RE: 327-355 Burley Road, Horsley Park (SSD-10436) – MOD 4 to Lot 204 (formerly 203) – Request for Additional Information - Transport Statement

Additional Swept Path Assessment and Design Commentary

Figure 2: B-double Exit Movements at Warehouses A and B

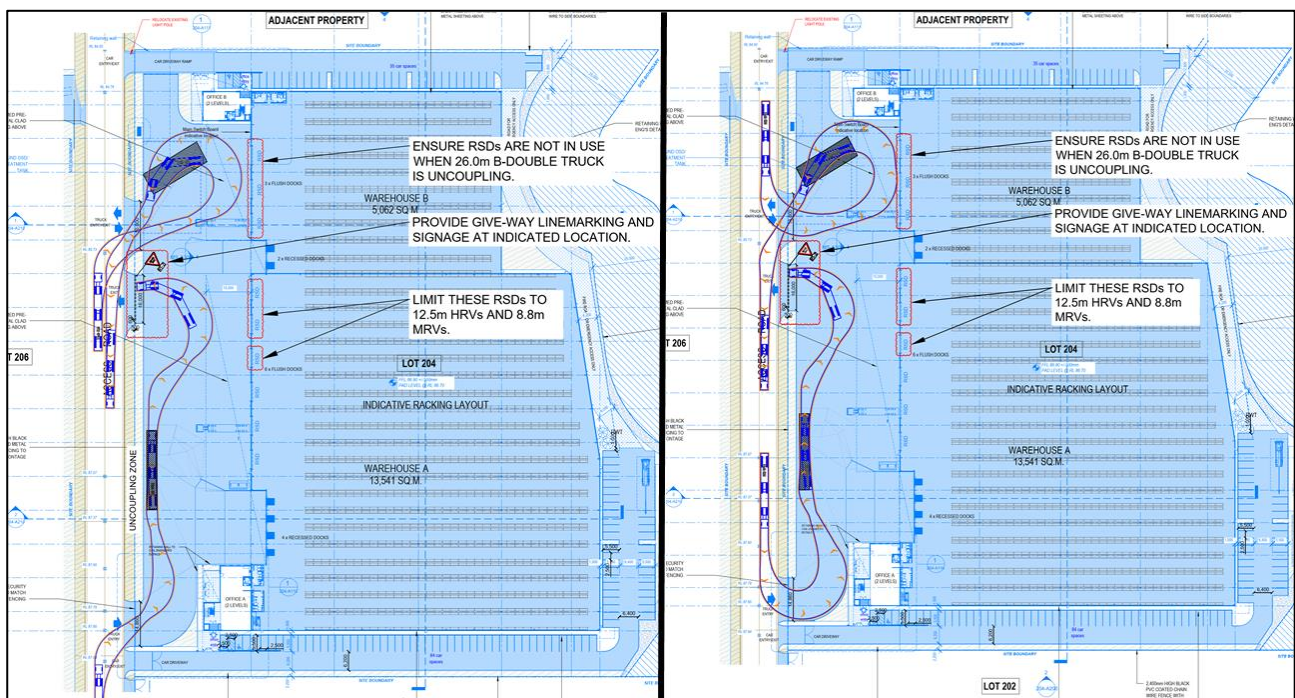
‘Should two 26 m B-Doubles associated with two tenants use the accesses concurrently, there is a potential conflict of movements at the accesses and potential impacts on other road uses travelling north-bound and south-bound on Johnston Crescent. Please clarify the manoeuvrability at the proposed truck accesses including swept path diagrams showing 26 m B-Doubles for both tenancies manoeuvring at the same time and any additional mitigation measures to ensure road safety where applicable.’

Based on the data provided within **Table 1** and **Table 2** (described in item 1.1), it is highly unlikely that B-doubles will be accessing Warehouses A and B at the same time. Therefore, it can be inferred that the probability of two B-Doubles accessing Warehouses A and B simultaneously and at any given time is close to zero.

Furthermore, it is noted that both Warehouses A and B can accommodate B-doubles. Notwithstanding, although Warehouse B provides for this provision allowing maximum flexibility for the tenant, there will be infrequent B-double movements at this warehouse. This is reiterated within the design assessment (AG1839-03-v03.dwg) which states that when B-doubles are entering / exiting from Warehouse B, there will be no other truck movements within this respective warehouse.

Further to the above reasons, with regards to potential conflicts for vehicles manoeuvring within the Site, tenants can manage heavy vehicle movements within the respective warehouses through a specific management plan. Operational management measures will take place to ensure potential conflicts will be minimised as much as practically possible.

Lastly, swept path diagrams showing B-doubles manoeuvring at the same time at Warehouses A and B is shown in **Figure 2** and within **Attachment A**.

Figure 3: Pages AG06 and AG07 of AG1839-03-v03.dwg

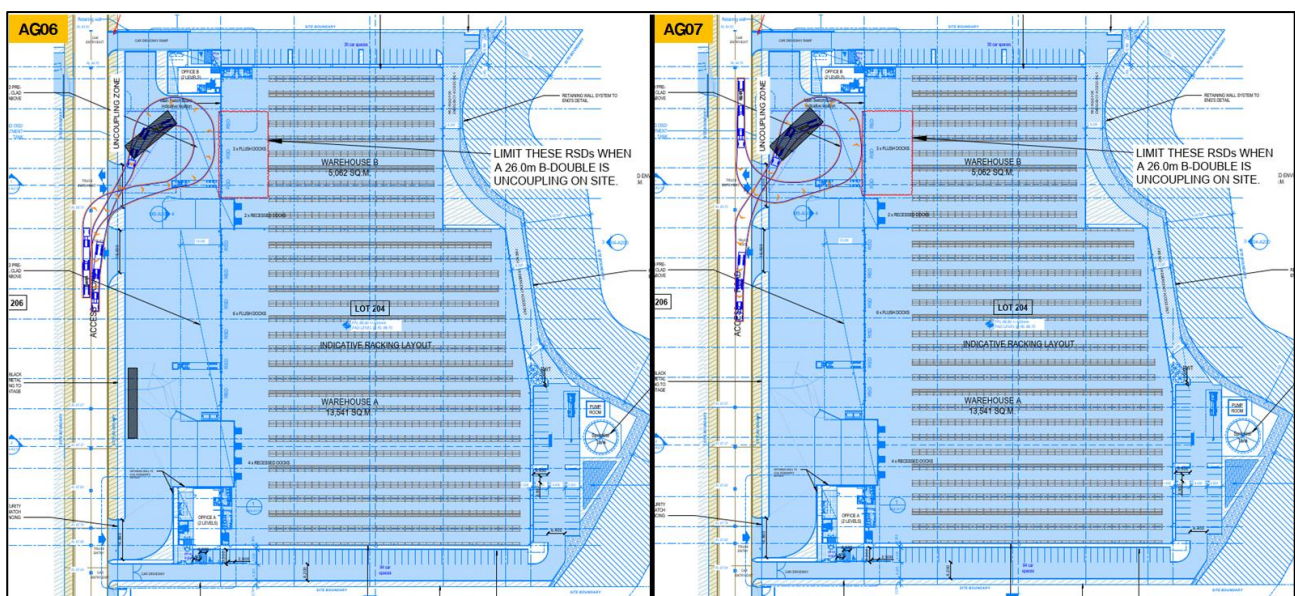
'The site does not make provision for a loading bay to accommodate 26m B-Double vehicles; Swept path diagrams (file names AG1839-03-v03.dwg sheets AG06 and AG07) indicate that a 26m B-Double vehicle manoeuvring within the site will be impacted by heavy vehicles parking at the recessed docks. Service vehicles shall only carry out loading and unloading activities from the designated loading areas and shall not obstruct the flow of traffic within the site. Additional information shall be submitted to address this concern;'

'Swept path diagram (file name AG1839-03-v03.dwg sheet AG06) indicates that 26m B-Double vehicle turn right into the site via the truck entry/exit driveway. It is anticipated that heavy vehicles would generally head south on Johnston Crescent to turn left into the site rather than making the right turn into the site. Clarification is required about this right-turn movement which is required to use the opposing traffic lane in order to turn into the driveway. Based on the applicant's swept path diagram (AG1839-03-v03.dwg sheet AG07), there is insufficient width at the entry/exit driveway to accommodate two-way simultaneous traffic movements i.e. left turn movement undertaken by a southbound 26m B-Double vehicle into the site and another vehicle waiting to exit the site. Concern is raised regarding 26m B-Double vehicle turning left from Johnston Crescent into the site via the entry/exit driveway which will conflict with other users;'

'Swept path diagram (file name AG1839-03-v03.dwg sheet AG06) indicates that 26m B-Double vehicle turn right into the site via the truck entry/exit driveway. It is anticipated that heavy vehicles would generally head south on Johnston Crescent to turn left into the site rather than making the right turn into the site. Clarification is required about this right-turn movement which is required to use the opposing traffic lane in order to turn into the driveway.'

'Based on the applicant's swept path diagram (AG1839-03-v03.dwg sheet AG07), there is insufficient width at the entry/exit driveway to accommodate two-way simultaneous traffic movements i.e. left turn movement undertaken by a southbound 26m B-Double vehicle into the site and another vehicle waiting to exit the site. Concern is raised regarding 26m B-Double vehicle turning left from Johnston Crescent into the site via the entry/exit driveway which will conflict with other users;'

To begin with, B-doubles will be able to uncouple within Warehouse B through the dedicated uncoupling zone.

Moreover, based on the information provided within **Table 2**, there is a very low probability that B-doubles will be accessing Warehouse B on a regular basis. Rather, B-doubles are expected to uncouple within Warehouse B once per week (if and when required). Therefore, it can be inferred that the likelihood of a B-double accessing Warehouse B is very low.

Through the implementation of an Operational Traffic Management Plan (OTMP), the tenant can ensure that when a B-double is entering / exiting from Warehouse B, **there would be no internal truck movements** within this building. This will guarantee that there will be minimal traffic conflicts between the B-double and other vehicles.

It is noted that AG06 (shown in **Figure 3**) indicates that a B-double would make a right turn in order to enter Warehouse B. This is mainly because for a temporary period of time until the signalised intersection (Old Wallgrove Road / Burley Road / Access Road 1) is constructed, vehicles will be utilising Johnston Crescent (from the south) in order to access the Site. In this regard, the swept path diagram shown within AG06 depicts a B-double turning right into Warehouse B and has been tested for conservativeness. Notably, during this temporary period, there will be no traffic conflicts with the opposing traffic lane as there will be no vehicles entering into the Site from the north.

Furthermore, it is noted that Council's comment regarding vehicles turning left into the Site does in fact apply to the Site when the signalised intersection (Old Wallgrove Road / Burley Road / Access Road 1) is constructed. In this regard, AG07 (shown in **Figure 3**) showcases vehicles turning left into the Site. This swept path diagram accounts for the ultimate truck entry movement strategies following construction of the signalised intersection in the future.

Finally, noting that B-Doubles movements from northbound and southbound along Johnston Crescent is possible, it can be concluded that the access design geometry is suitable and provides for future-proofing of the Site.

AG07 (shown in **Figure 3**) indicates that a B-double would make a left turn in order to enter Warehouse B.

Notably, based on the information provided within **Table 2**, there is a very low probability that B-doubles will be accessing Warehouse B on a regular basis. Rather, B-doubles are expected to uncouple within Warehouse B once per week (if and when required). Therefore, it can be inferred that the likelihood of a B-double accessing Warehouse B is very low and that there will be minimal traffic conflicts between the B-double and other vehicles within Warehouse B.

Figure 4: Pages AG04 and AG05 of AG1839-03-v03.dwg

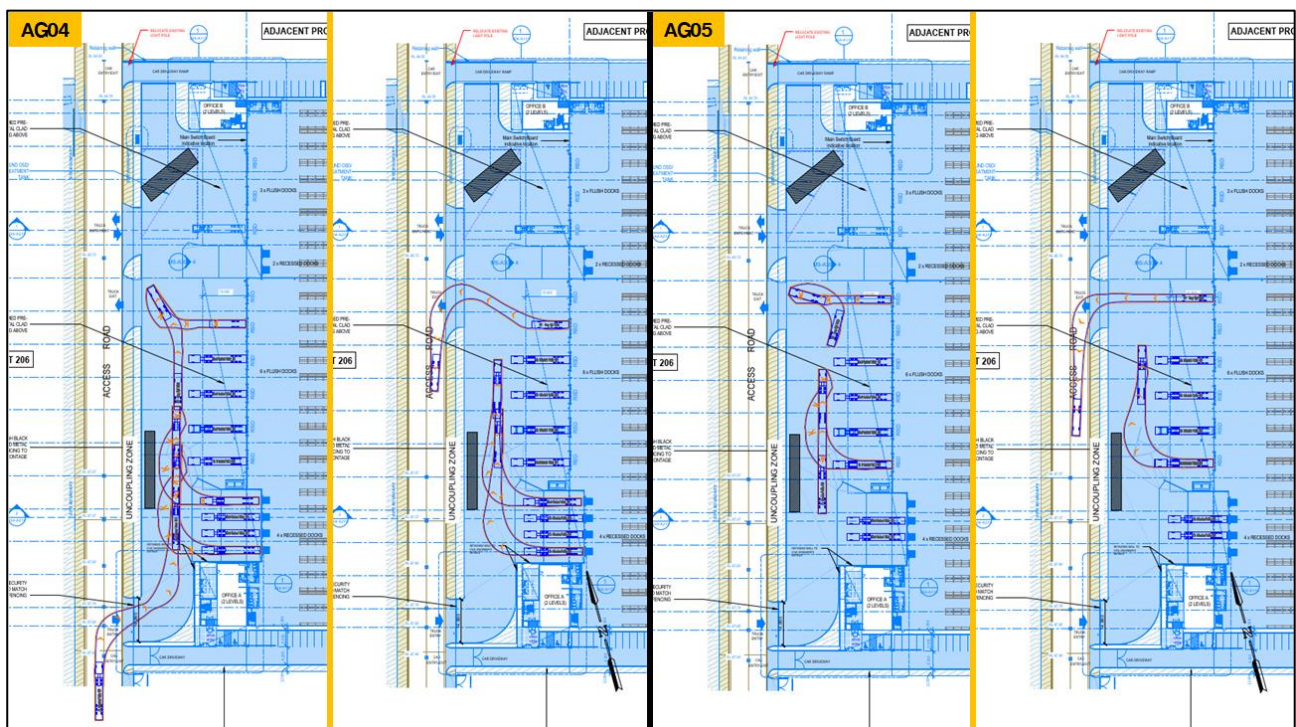
'Swept path diagrams (file name AG1839-03-v03.dwg sheets AG04, AG05 and AG06) show the proposed uncoupling zone adjacent to the recessed loading docks would impact heavy vehicles turning into and out of the loading docks. Additional shall be submitted to Council to address this concern;'

AG04 and AG05 (shown in **Figure 4**) indicate the black hatched area as the uncoupling area for B-doubles within Warehouse A. Notably, the swept path diagram indicates that when vehicles are entering / exiting from the respective loading docks within Warehouse A, they will not be obstructed by the uncoupling zone. All the swept path diagrams are clear of the uncoupling zone.

Furthermore, based on the data within **Table 1**, the daily B-double volumes are very low (approximately one truck) for Warehouse A. It is noted that a B-double (if needed on a very rare occasion) will uncouple to the west of the proposed RSDs and recessed docks (as shown in **Figure 4**). Again, it is important to emphasise that during normal operation, there will be no frequent movements of B-doubles. Therefore, this occurrence will happen very infrequently.
